Access Compliance Report Public Rights-of-Way (Curb Ramps)

Main Street: SHAKESPEARE_DR		Cross Street: WEMBLEY_RD		Location:	S
ADA ID: RPAT211201100657	Ramp Type:Type 1 - Perpendicular Diagonal Initial Pass/Fail: Fail		Overall Compliance: No	Severity Score:	15
Codes/Mitigation Info/Possible Solution			Field Measurements/Component Compliance

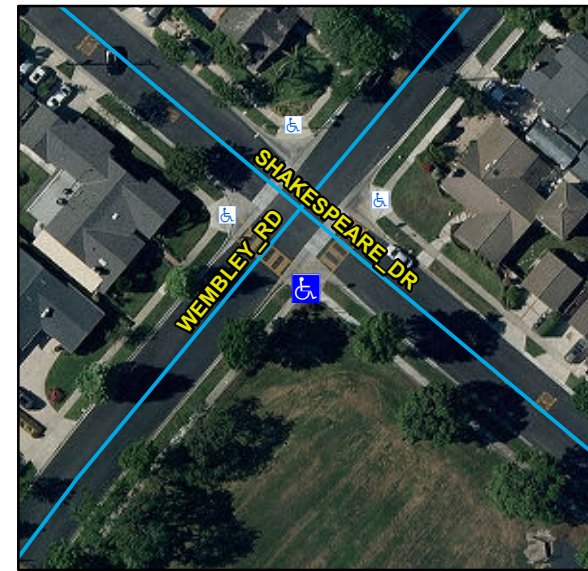
Compliance	Description	Data	Compliance	Description	Data
N/A	Ramp Length (in)	80	N/A	Flare Type LT	
Yes	Ramp Width (in)	48			N/A
No	Ramp Run Slope (%)	8.4	N/A	Flare Slope LT (%)	N/A
Yes	Ramp Cross Slope (%)	0.6	N/A	Flare Traversable LT	N/A
N/A	Landing Present	N/A	N/A	Flare Type RT	
N/A	Landing Length (in)	N/A			N/A
N/A	Landing Width (in)	N/A	N/A	Flare Slope RT (%)	N/A
N/A	Landing Run Slope (%)	N/A	N/A	Flare Traversable RT	N/A
N/A	Landing Cross Slope (%)	N/A	N/A	DWS Provided	N/A
N/A	Landing Movement Obstructed?	N/A	N/A	DWS Contrast	N/A
	Landing Movement Type	N/A	N/A	DWS Length (in)	N/A
N/A	Landing Shared	N/A	N/A	DWS Full Width	N/A
N/A	Clear Space	Yes	N/A	DWS Offset Left (in)	N/A
N/A	Clear Space To Crosswalk (in)	N/A	N/A	DWS Offset Right (in)	N/A
N/A	Marked Crosswalk 1	No	N/A	Marked Crosswalk 2	No
	Crossing 1 Direction	NE		Crossing 2 Direction	NW
	Marked Crosswalk 1 Width (in)	N/A		Marked Crosswalk 2 Width (in)	N/A

Remove & Replace Curb Ramp With Two New Directional Ramps or Equivalent.
